SERVICE BULLETIN

Classification: BT03-015	Reference: NTB03-063	Date: June 25, 2003
-----------------------------	-------------------------	------------------------

2003 350Z; FRONT CLOTH SEAT BOLSTER WORN

Figure 1 - Driver's seat shown

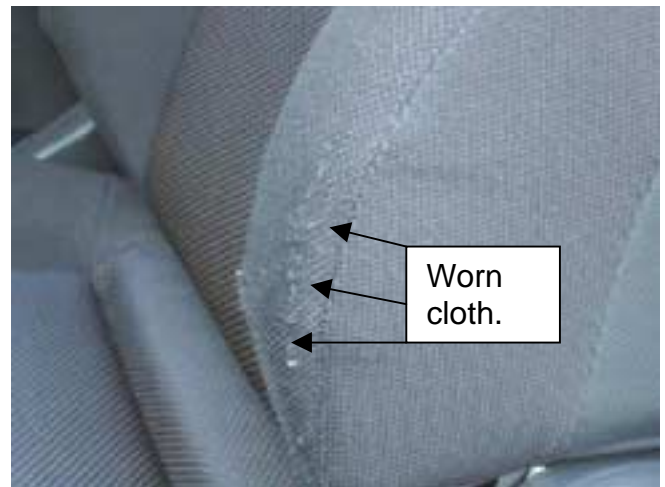
The seat cloth bolster on a front seat is worn as shown in Figure 1.

- Remove the worn seat from the vehicle.
- Remove the head restraint assembly from the seatback. Then remove the seatback from the seat cushion.
- Replace the head restraint assembly, seatback cover, and seat cushion cover with the correct ones from the **PARTS INFORMATION** section of this bulletin.
- Reinstall the seatback onto the seat cushion. Then reinstall the head restraint assembly onto the seatback.
- Reinstall the seat into the vehicle.
